RFI

RFI #: 78
 Date: 3/16/2012
 Job: EB-02 Keller Springs Lofts
 Phone: 877-777-5115

RFI #: 117
 Date: 5/15/2012
 Job: EB-02 Keller Springs Lofts
 Phone: 877-777-5115

RFI #: 135
 Date: 5/31/2012
 Job: EB-02 Keller Springs Lofts
 Phone: 877-777-5115

Subject: Slab at Club Poured Short

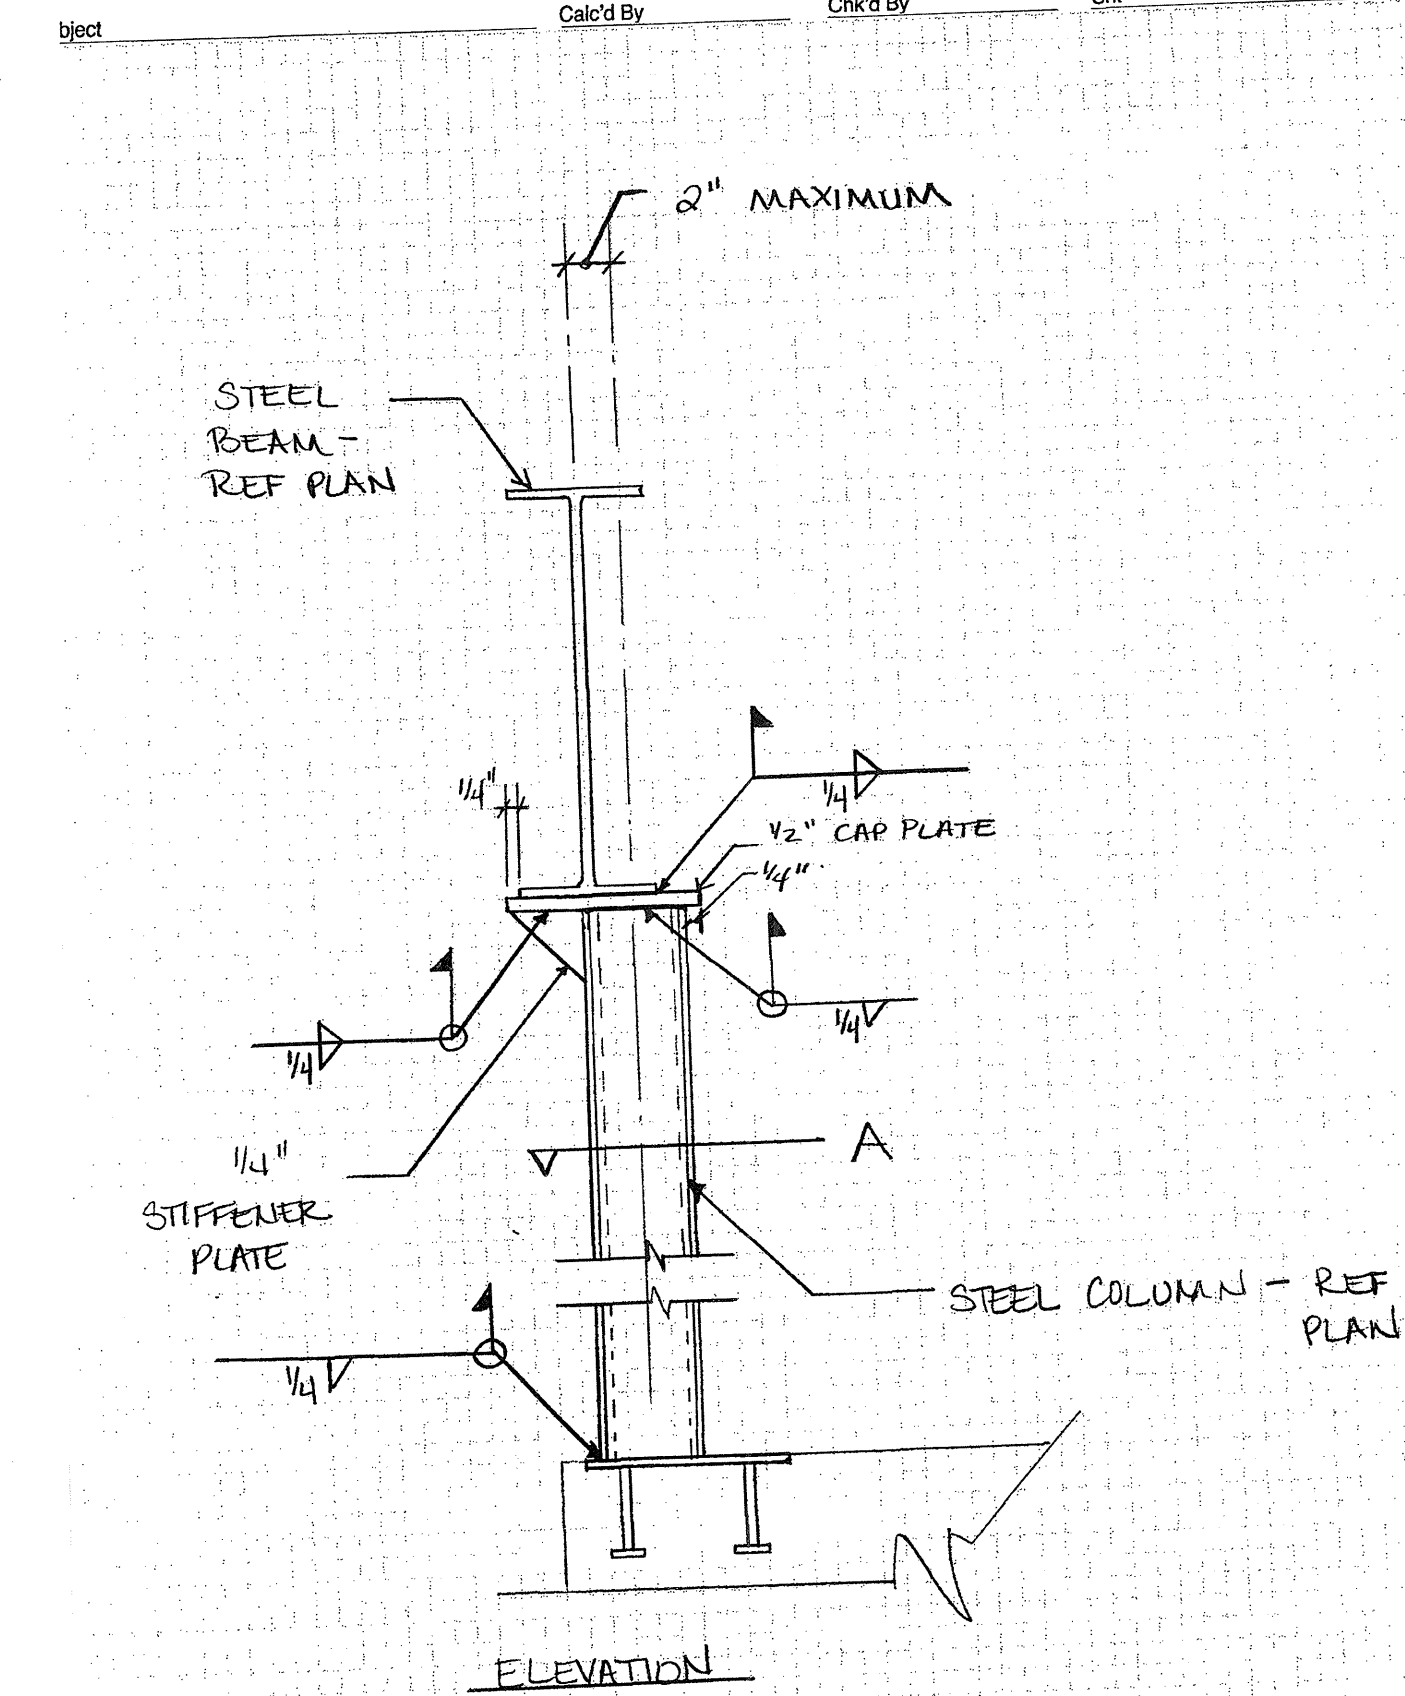
Request:
 On the courtyard side of the Club, where the 45 degree angle is, the concrete slab form board was about 2 inches short right in the angle. Please provide a fix for the following:
 1. How can the steel beam be positioned to carry the exterior wall of the floors above?
 2. How can the slab be repaired so that we have the correct dimensions for the exterior wall of the clubhouse?

Response:
 Per the conference call on May 30, 2012, the beams will remain in the current locations indicated on the drawings and modifications made per the attached sketches. The columns will be attached to the embed plates at their current locations. The maximum offset of the column from its intended location on the structural drawings is two (2) inches. If this limit cannot be maintained with the current locations of the embeds, contact PPO for additional remedial recommendations.

Subject: Ramp and Gradebeam at NW Corner of Garage

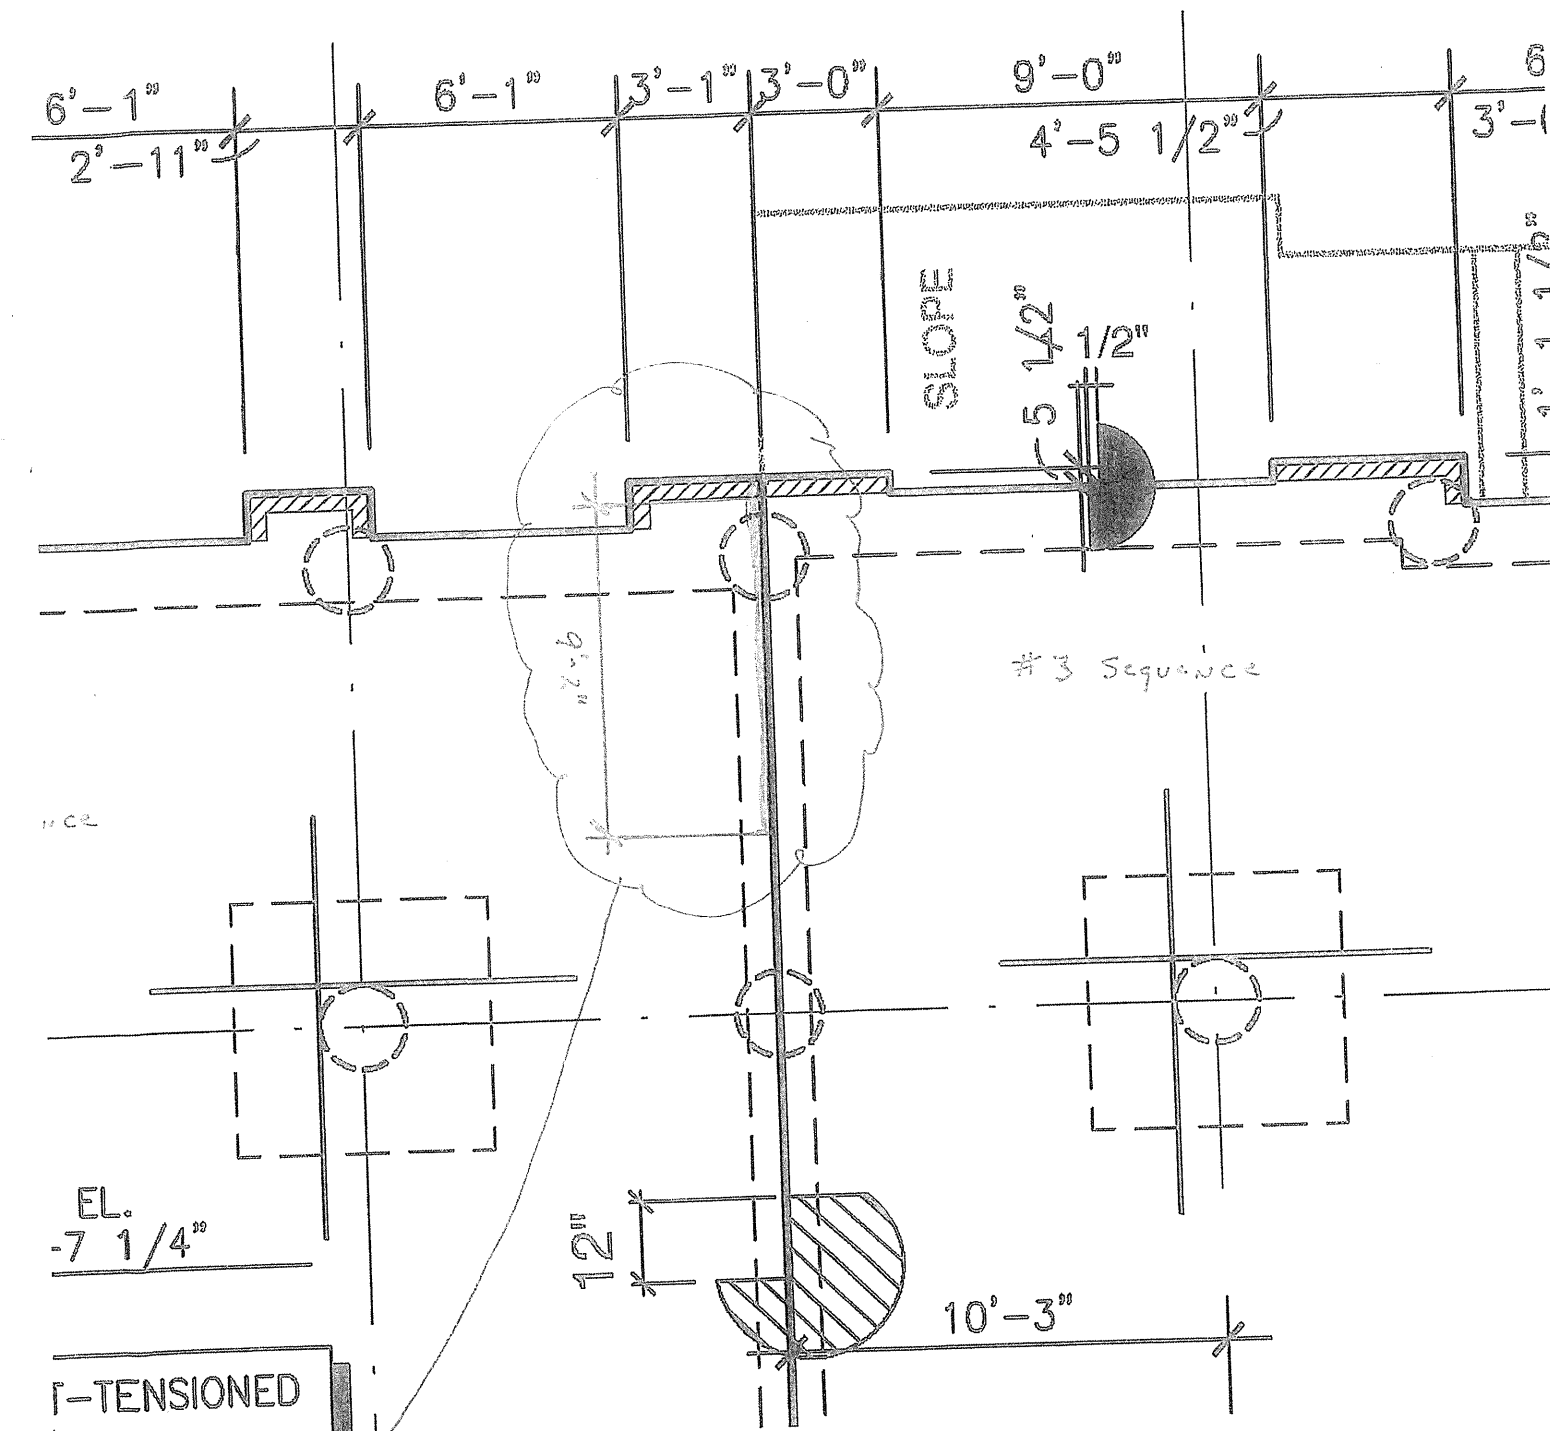
Request:
 The P5 top of pier elevation at the SW corner of Pour 5 will not allow enough room for the ramp. FF should be at 640.1', which would mean we would have a shorter gradebeam than the typical 2'-0". Please confirm if we are to have an 18" gradebeam there and also confirm where the stepdown is from the P9 pier to the P5 pier. Also provide a detail or cut through that area.

Response:
 Step top of grade beam down 6" at ramp only. Grade beam depth to remain 24" at all other areas.
 See 6/S3.01 for additional information.
